**APPENDIX E.5: Minutes and Resolutions for New Items from Study Team by the Letter on  
October 1999**

**THE NORTH SINAI INTEGRATED RURAL DEVELOPMENT PROJECT (PHASE III)**

CONVEYANCE CANAL SYSTEM  
 BETWEEN THE END OF EL EL AND ZONE  
 UNTIL THE BEGINNING OF EL SIR AND EL KAWAR ZONE

Longitudinal Section of No.1 Opening

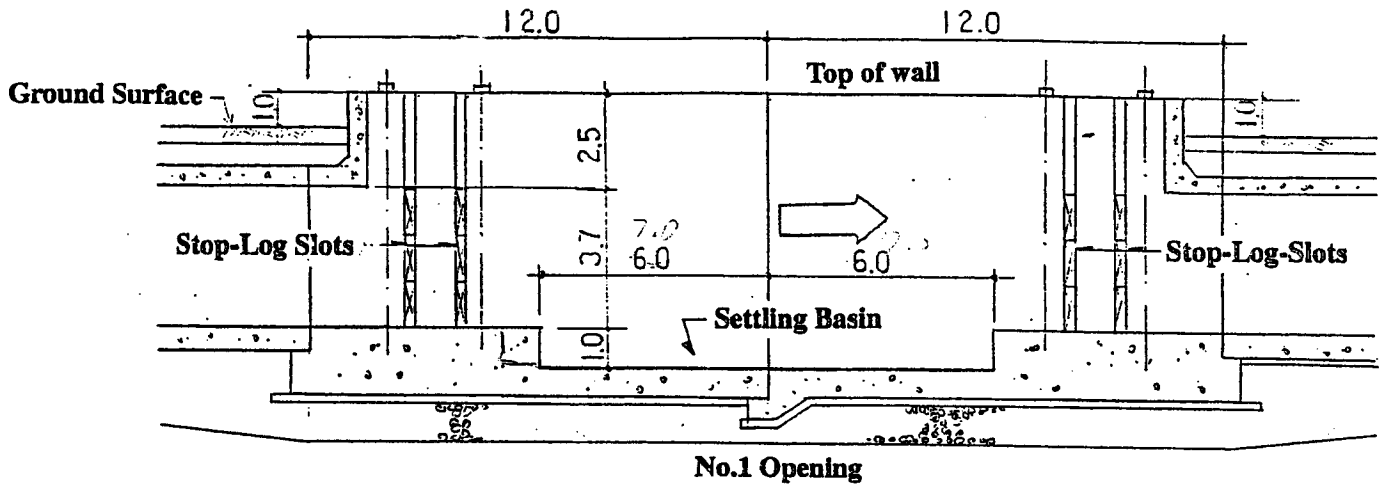
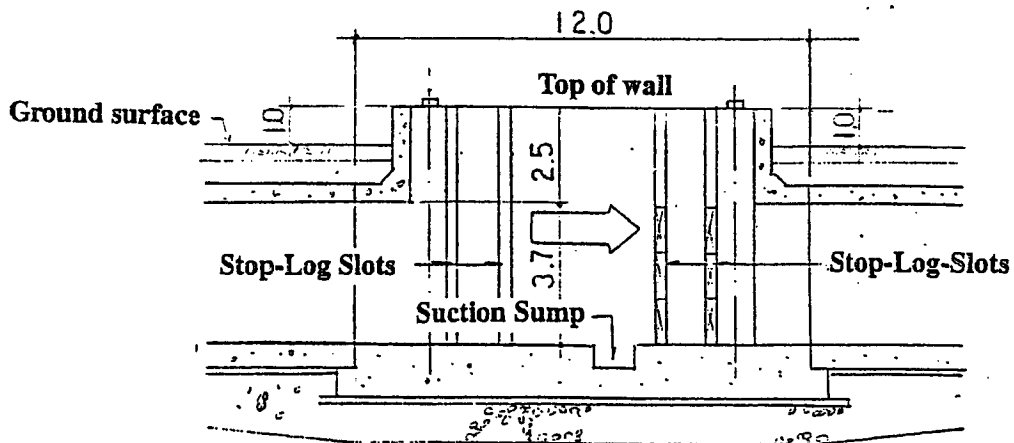
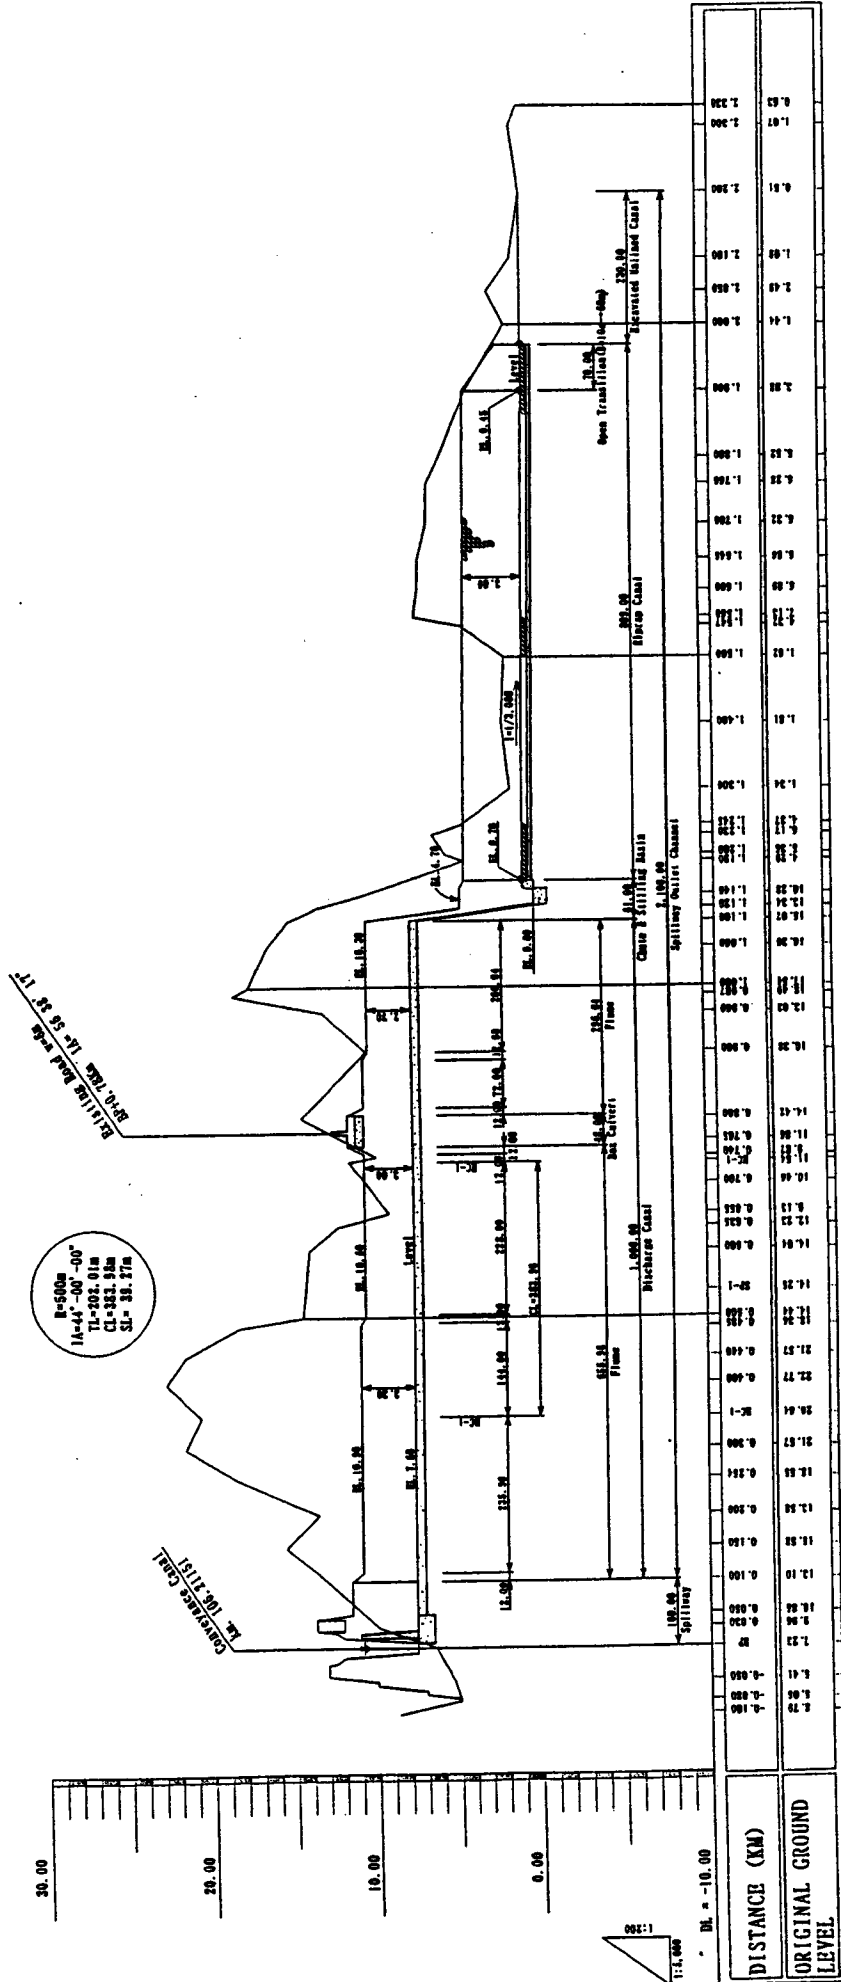
Safety devices such as safety fence, handrail, etc. are not installed.

Safety devices such as safety fence, handrail, etc. are not installed.

5.1 : Item 1. Sub-item d), safety racks with diameter 2 inches steel pipe shall be installed with 0.30 m interval instead of 0.15 m interval which are discussed at the meeting, due to too narrow the pipe space each others)

5.2 : Item 1. Sub-item e), we accept to install safety slab on the opening part of box culvert but cancel provision of handrail on the wall top of the openings.

SAMPLE OF SAFETY FENCE (BARBED WIRE FENCE)

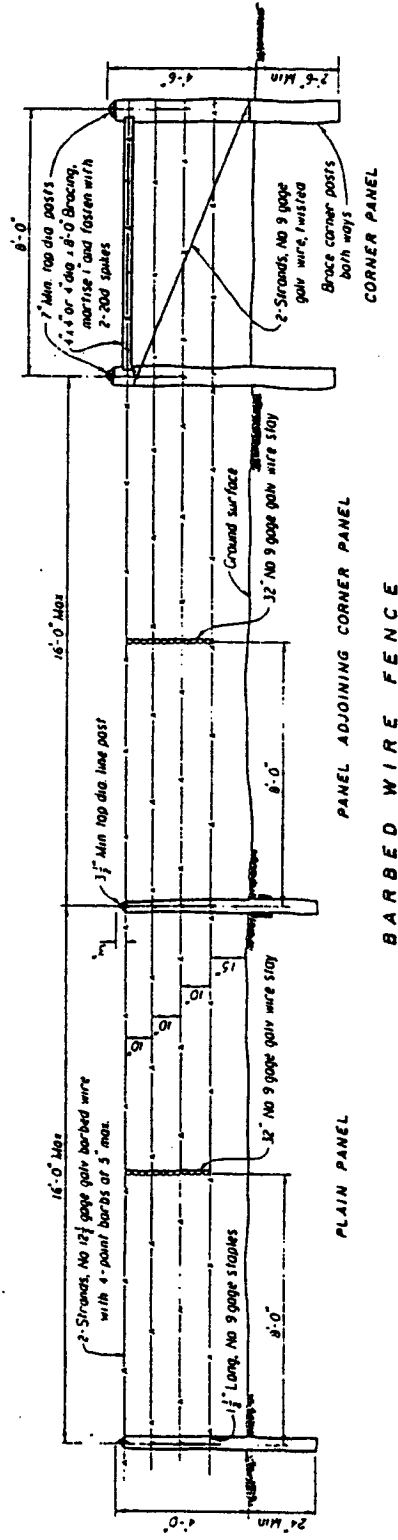
<p>b) Capacities of Slope Trimming Machine and Lining Machine ( ? m/hr)</p> <p>c) Give us the drawing of "Kilometer Sign" (Pay item No.31 of BQ for the work between KM 73.00 and KM 86.50).</p> <p>d) Please teach us whether it is proper to install safety fence along the outlet channel. (Refer to Appendix-9)</p>	Package	Location	Size	1	Bir El Abd (?)	?	2	El Arish (?)	?	3	El Arish (?)	?	4	?	?
Package	Location	Size														
1	Bir El Abd (?)	?														
2	El Arish (?)	?														
3	El Arish (?)	?														
4	?	?

Sub-item d) : Safety fence along the concrete flume canal shall be provided as indicated fence details.
